City of Portland, Maine – Building or Use Permit Application 389 Congress Street, 04101, Tel: (207) 874-8703, FAX: 874-8716

Location of Construction: 43 Vera St		Owner: Cunningham, George & Leigh		Phone:		Permit No 971055	
Owner Address: SAA Ptld, ME 04103		Lessee/Buyer's Name:		Phone: 772-9020		BusinessName:	
Contractor Name: SAA		Address:		Phone:		<div style="border: 2px solid black; padding: 5px; text-align: center;"> PERMIT ISSUED Permit Issued: OCT - 2 1997 CITY OF PORTLAND </div>	
Past Use: 1-fam		Proposed Use: Same		COST OF WORK: \$ 2,000.00 PERMIT FEE: \$ 30.00			
Proposed Project Description: Install Interior stairway & Window		FIRE DEPT. <input type="checkbox"/> Approved <input type="checkbox"/> Denied Signature: _____		INSPECTION: Use Group: Type: <i>ok with conditions</i> Signature: <i>10/1/97</i>		Zoning Approval: Zone: R-3 CBL: 162-B-030 <i>ok with conditions</i> Special Zone or Reviews: <input type="checkbox"/> Shoreland <input type="checkbox"/> Wetland <input type="checkbox"/> Flood Zone <input type="checkbox"/> Subdivision <input type="checkbox"/> Site Plan maj <input type="checkbox"/> minor <input type="checkbox"/> mm <input type="checkbox"/>

REASON FOR PERMIT:

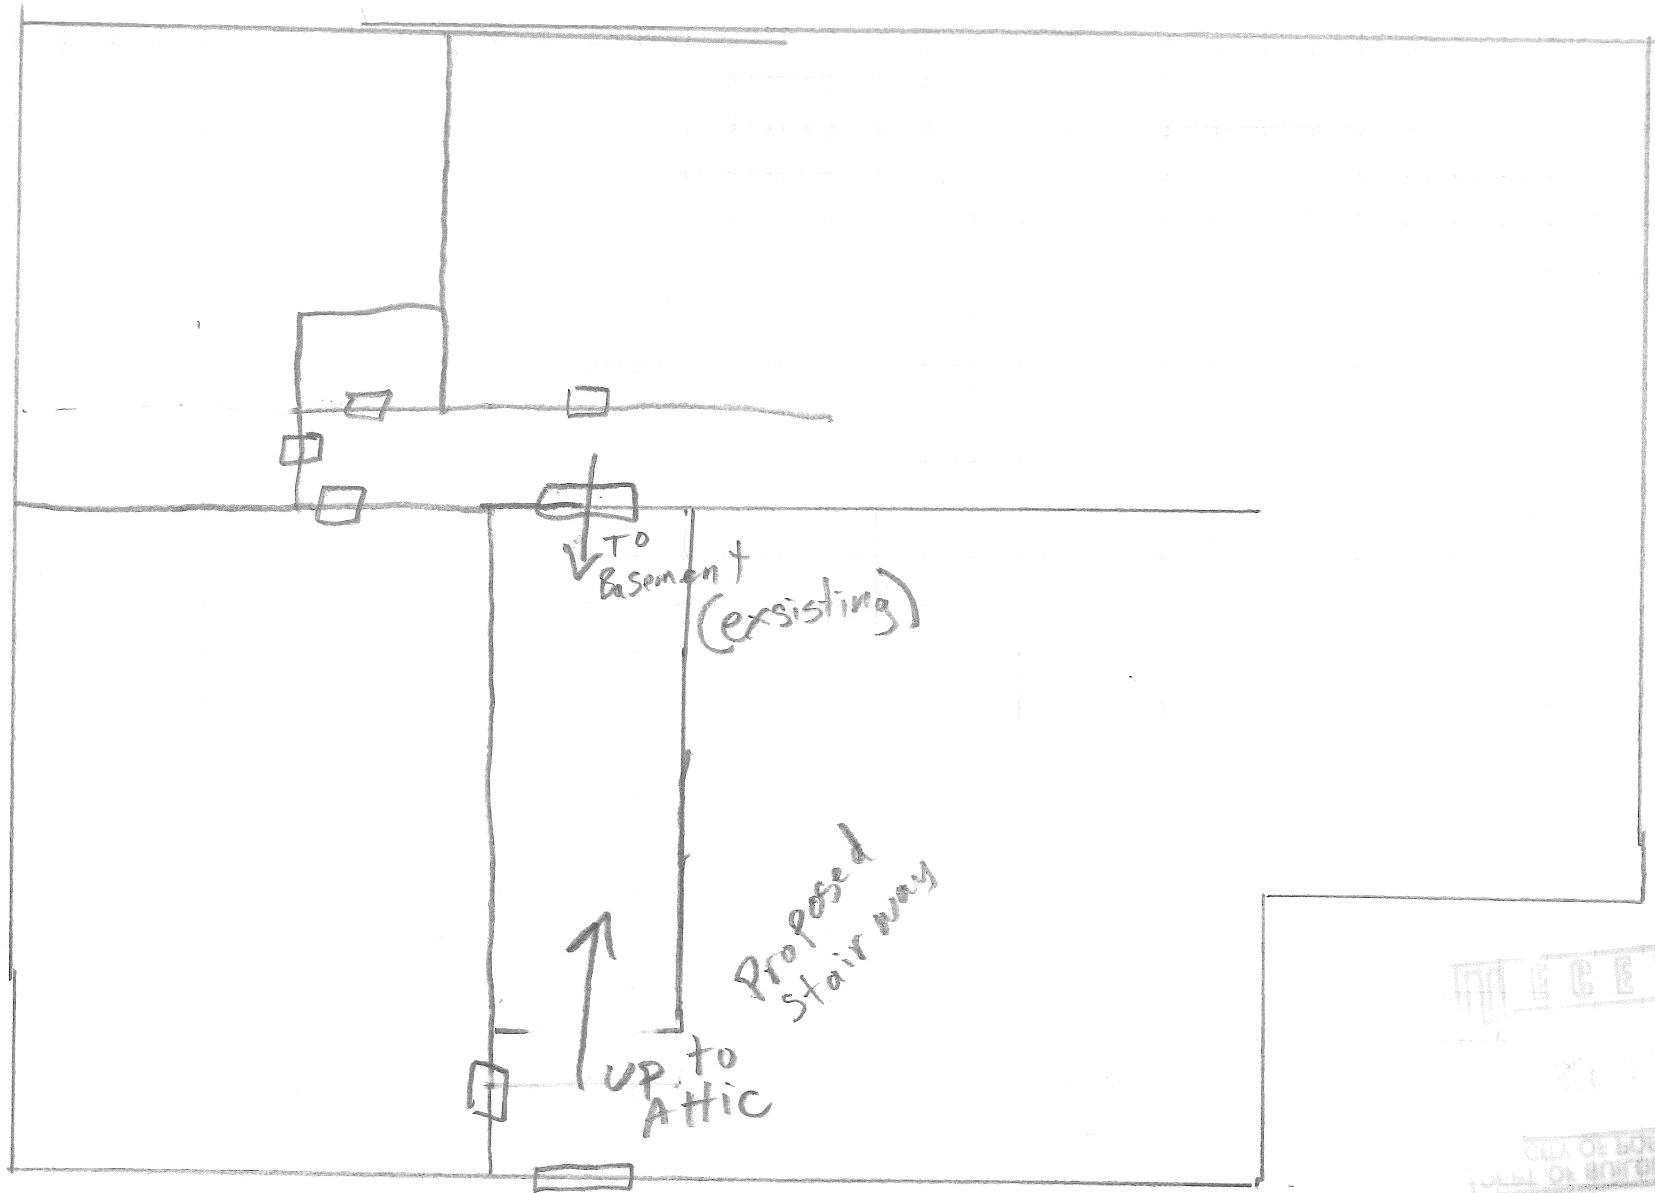
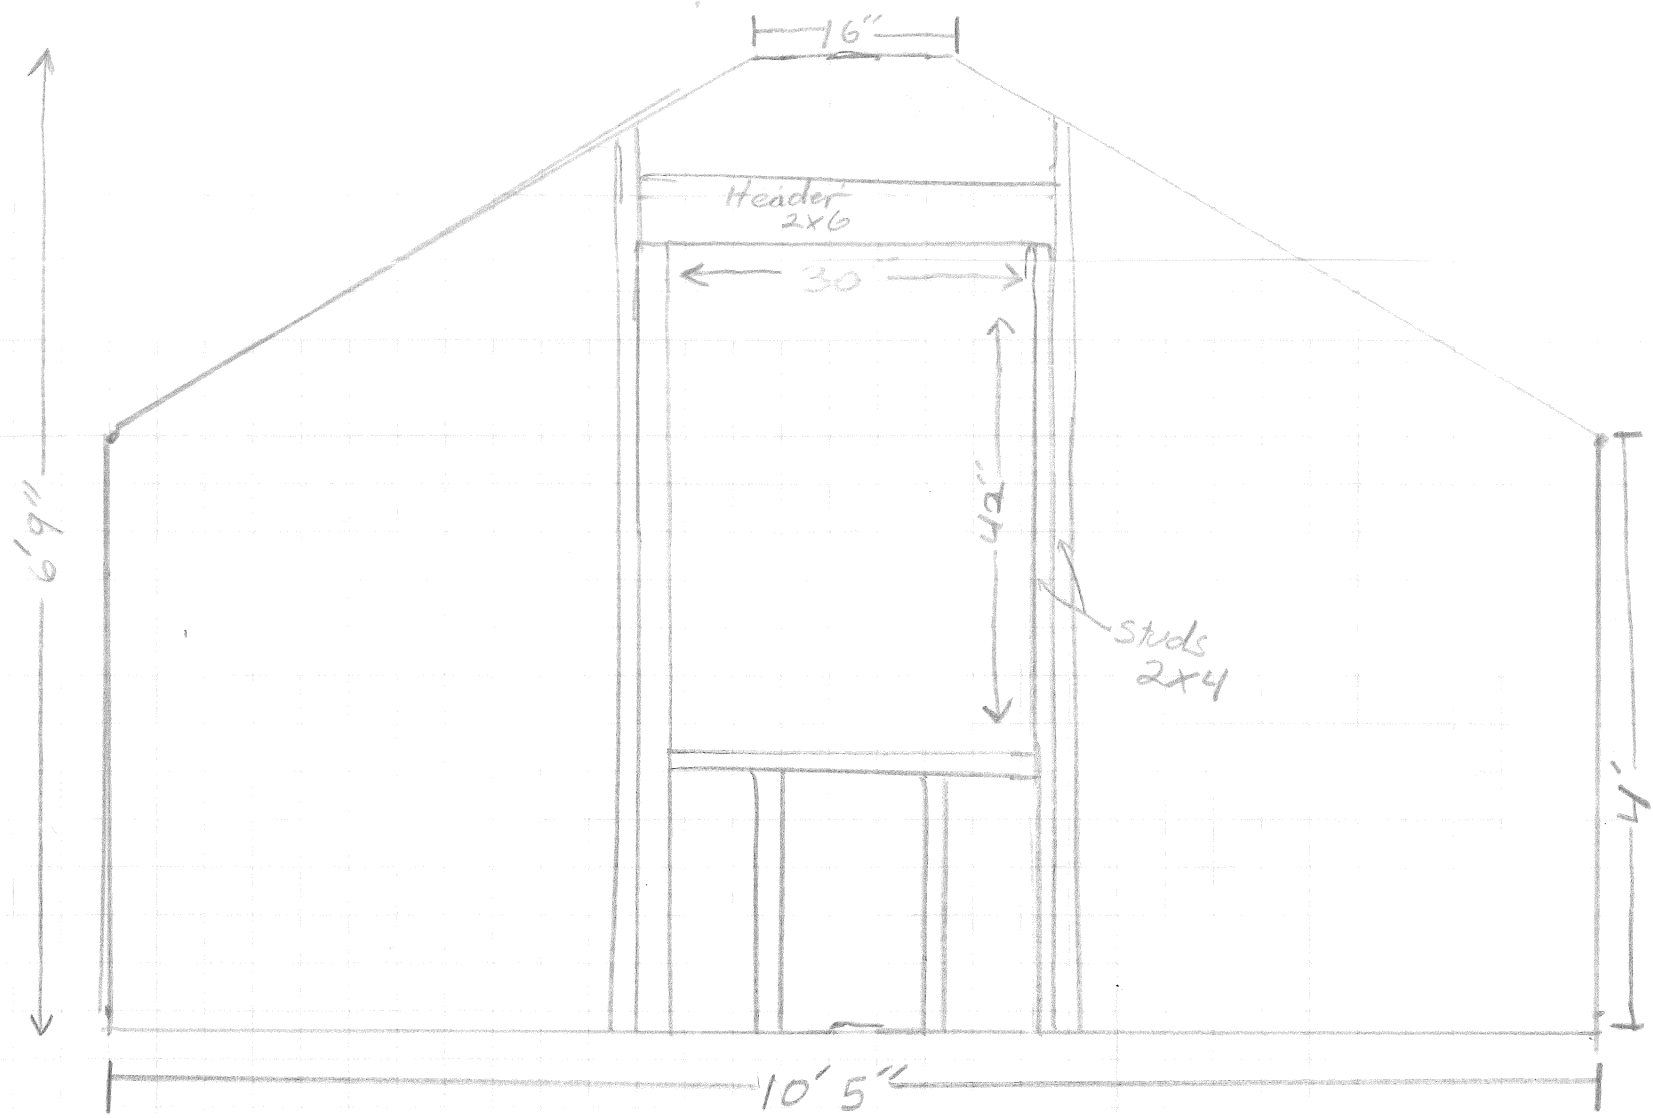
- 30. *No structural plans were submitted with this application. You must contact your inspector prior to beginning work with details of your stairway construction.*
